To: Plan Holders for Improvements to the
Monett Regional Airport
Pierce City, Missouri
Project No. 20-098B-1

Schedule I – Earthwork and Grading for Relocation of Runway 18/36

**ADDENDUM NO. 4
TO
CONTRACT DOCUMENTS, SPECIFICATIONS AND PLANS
FOR IMPROVEMENTS TO THE
MONETT REGIONAL AIRPORT
PIERCE CITY, MISSOURI
PROJECT NO. 20-098B-1**

C602

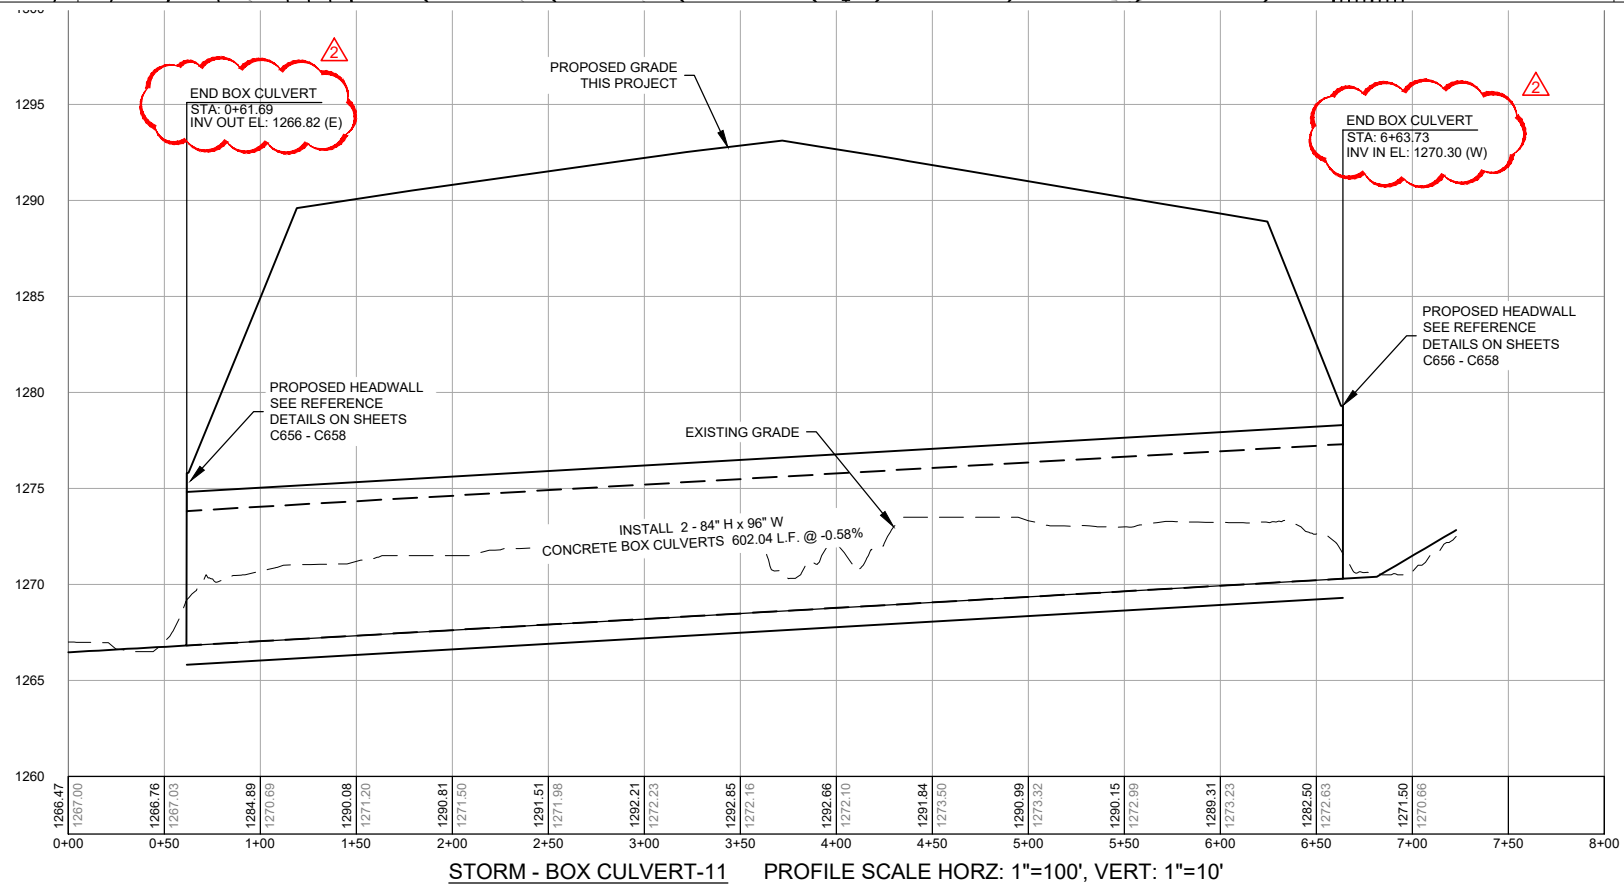
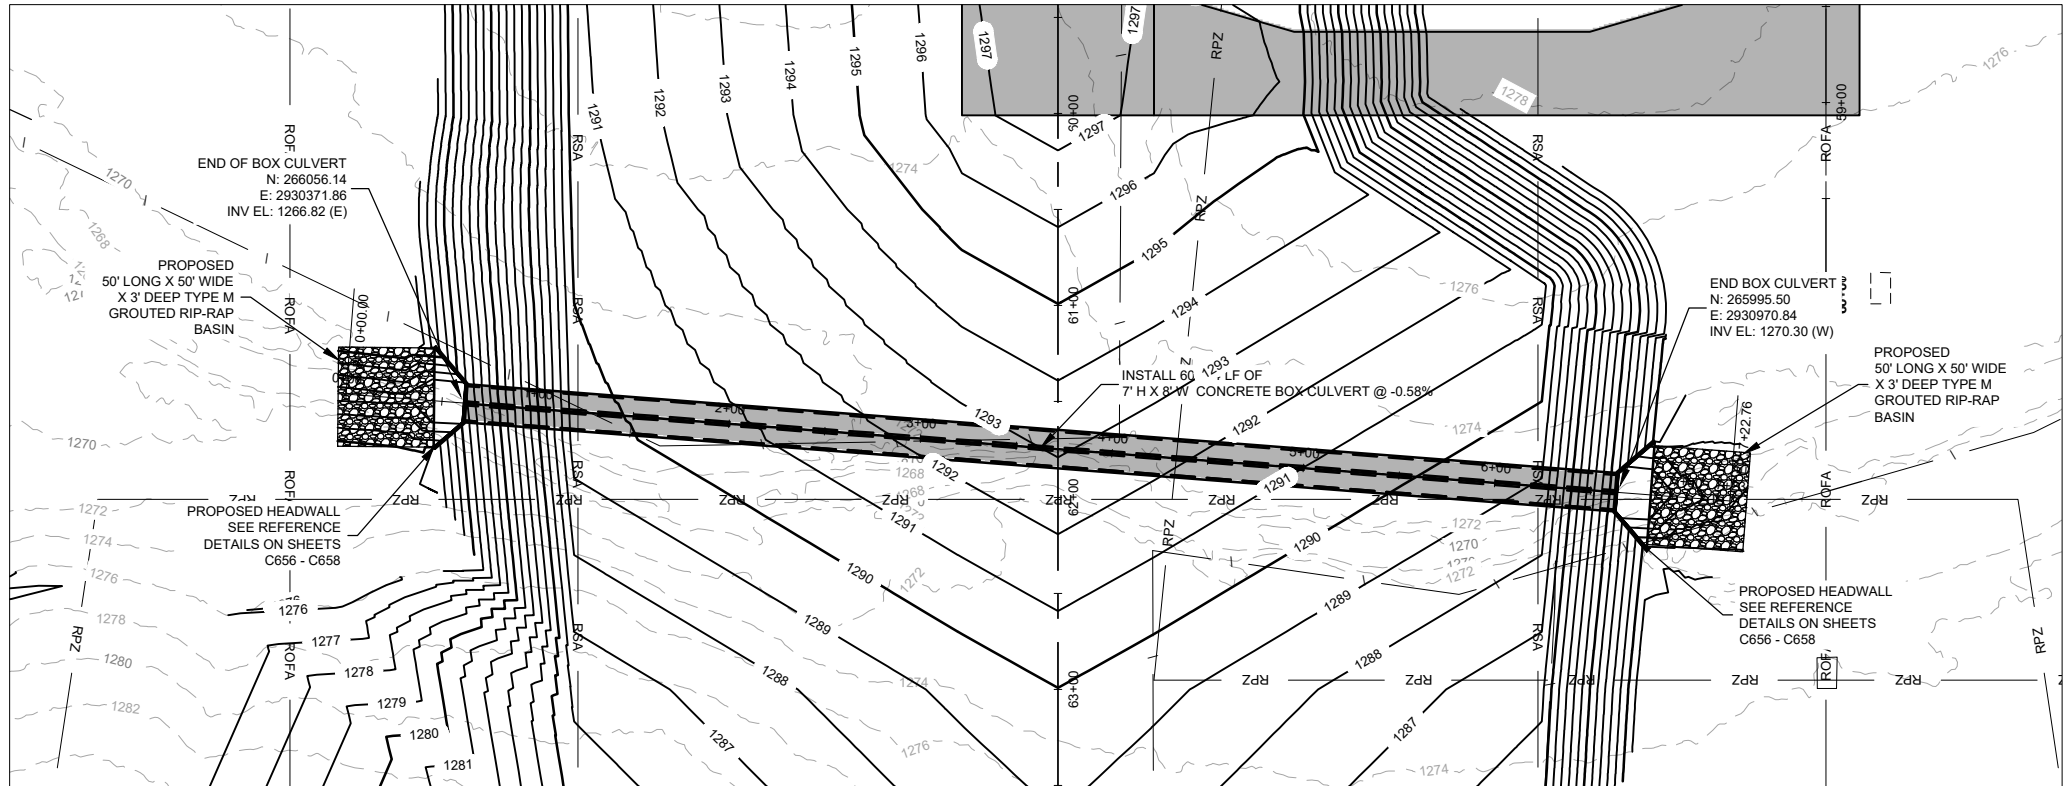
25. Inlet #2 is noted as a double inlet, however this conflicts with Note No. 1 on Sht. C655, noting a triple inlet be used where pipe is between 36" & 66". See also related question pertaining to bid form.

- a. Inlet has been revised to a Triple Type 1 Inlet, see revised sheet C602, attached.

C650

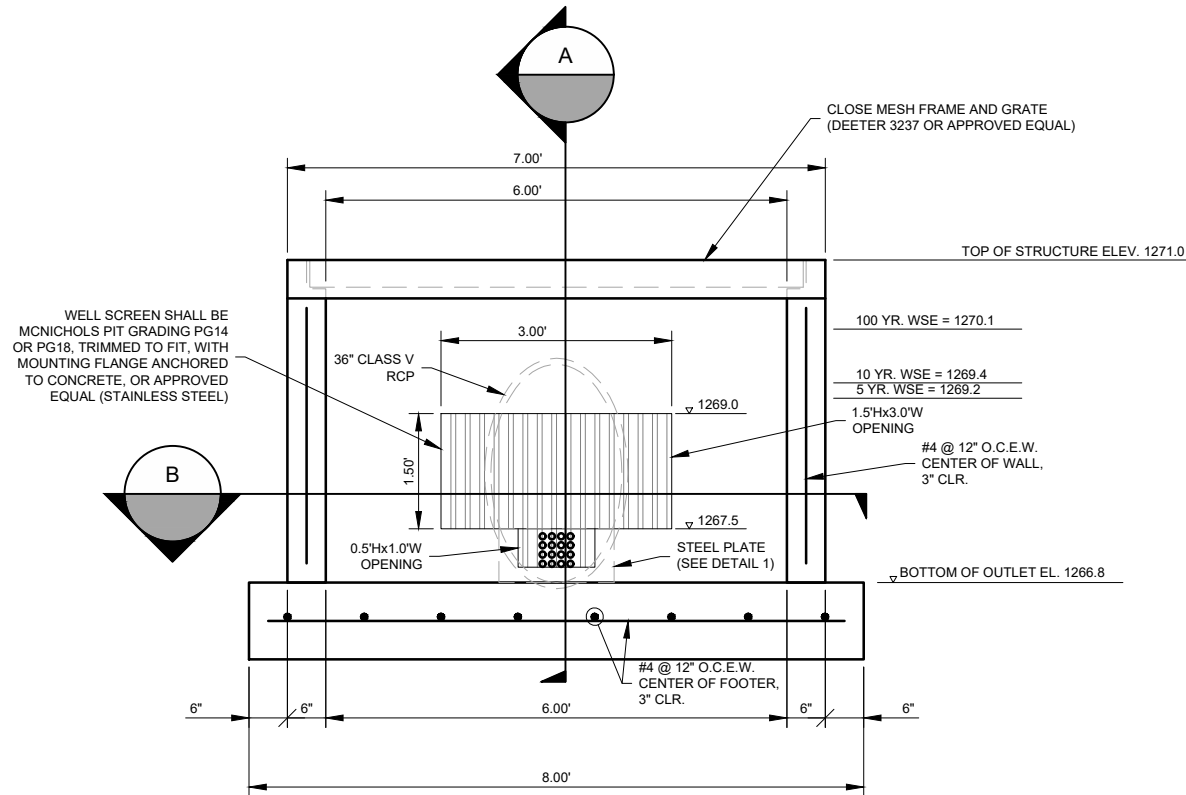
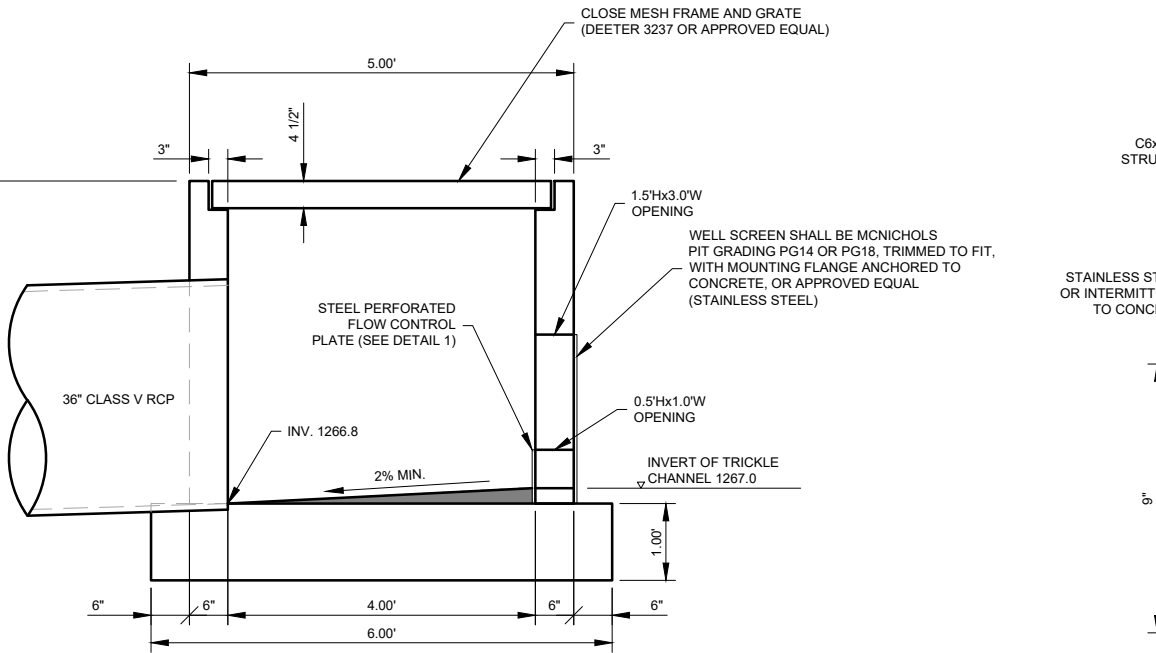
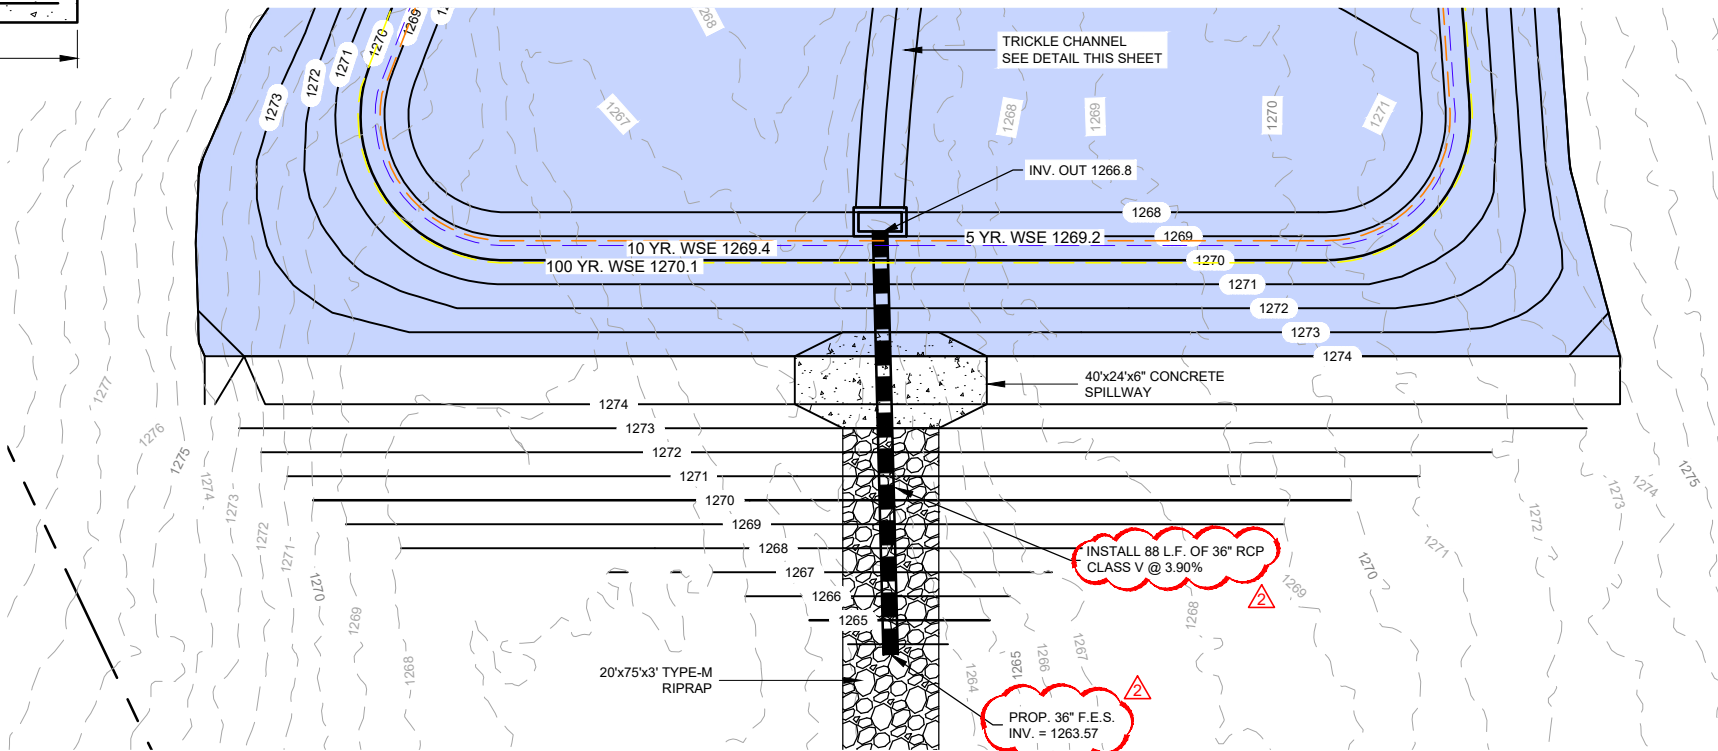
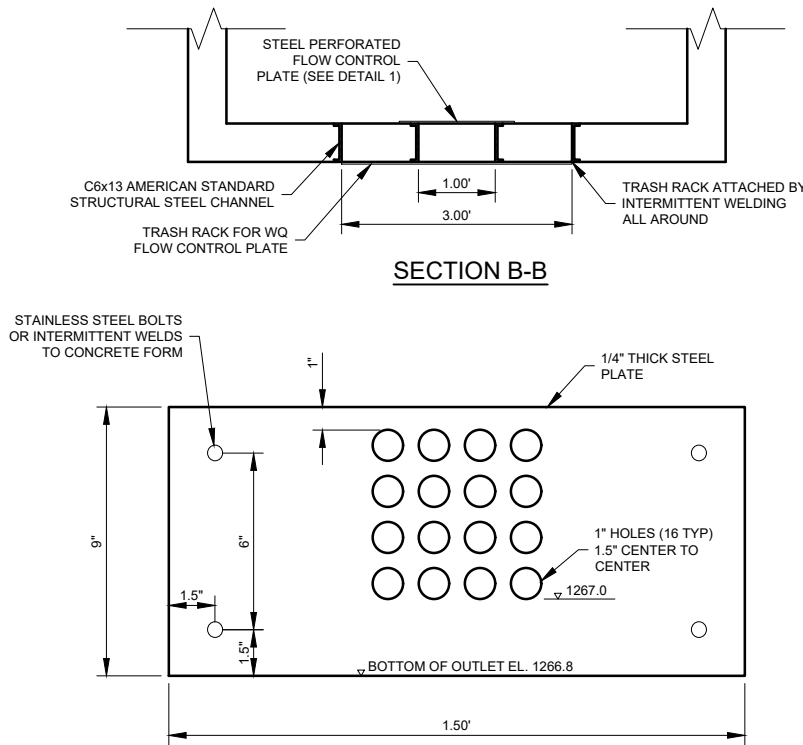
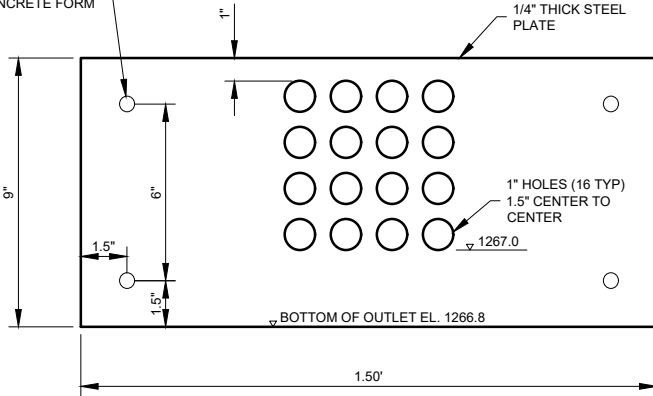
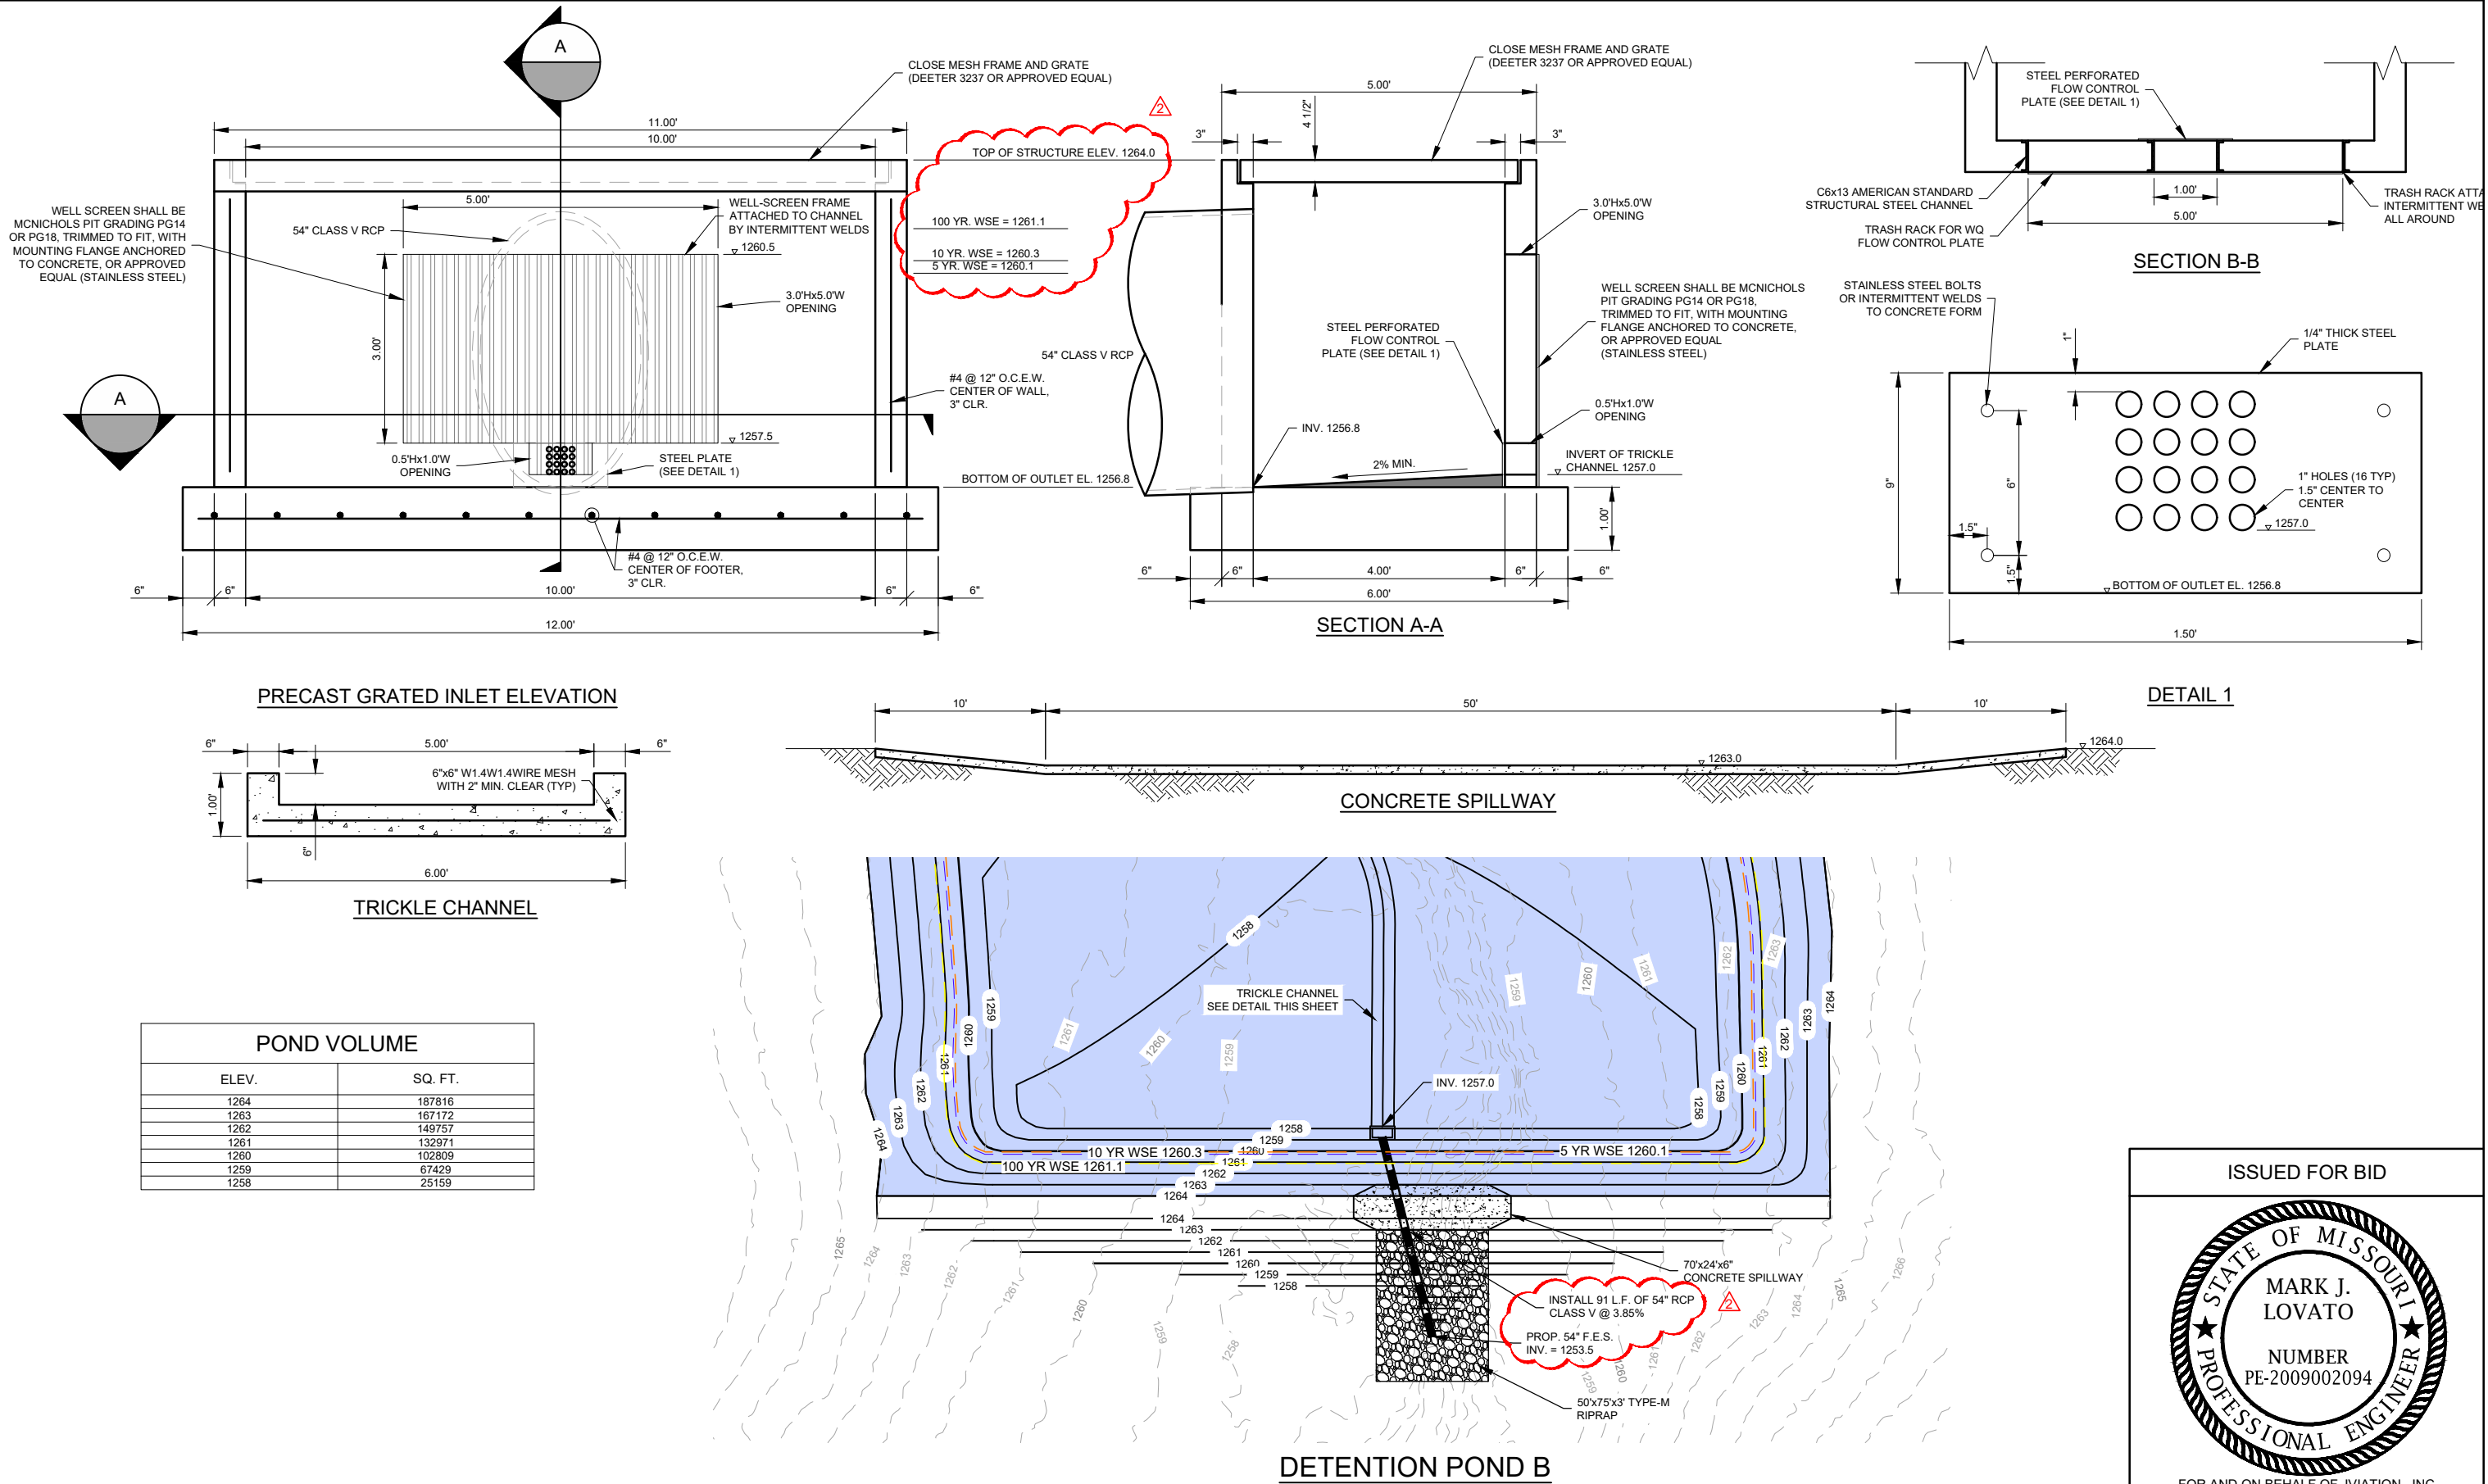
Sheets: C650-C652

Title: Detention Pond Outlet Structure

Revision: Updated plan to show pipe and FES size and updated elevation requirements on Pond B.

- a. Yes, see revised sheets C650-C652, attached.
20. The outlet control structure for Det. Pond "B" shows a rim elevation of 1271 (same as Pond "J"), but the spillway is 1263. Is this intentional?
